Remarks

This amendment is responsive to the official action mailed May 26, 2004, and is accompanied by a Petition for Extension under 37 C.F.R. §1.136(a) and the fee required for a two month extension.

Docket No. 3201-337
[D4700-00350]

Fig. 13

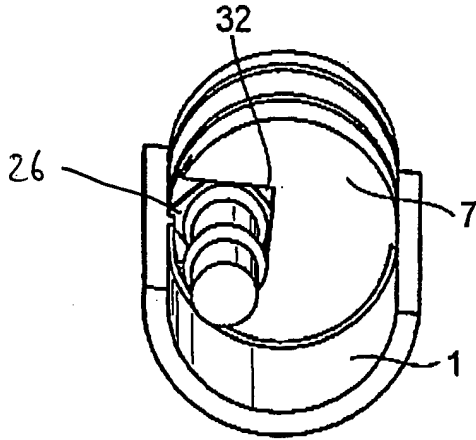
Also submitted are proposed drawing corrections. Objection was made to the drawings for the presence of extraneous lead lines, notations in German, and some improper crosshatches in the cross-sections. In response, the drawings have been corrected and Applicant submits herewith corrected replacement drawing sheets and annotated copies. The following additional changes have been made to the drawings: (1) the lead line for the reference numeral 15 in Fig. 9 has been revised to point to the correct structure as provided by the original Specification; (2) a corresponding reference numeral "15" for the undercut has been added to Fig. 10; and (3) a reference numeral "26" for the square-shaped flange has been added to Fig. 13 as provided by the original Specification.
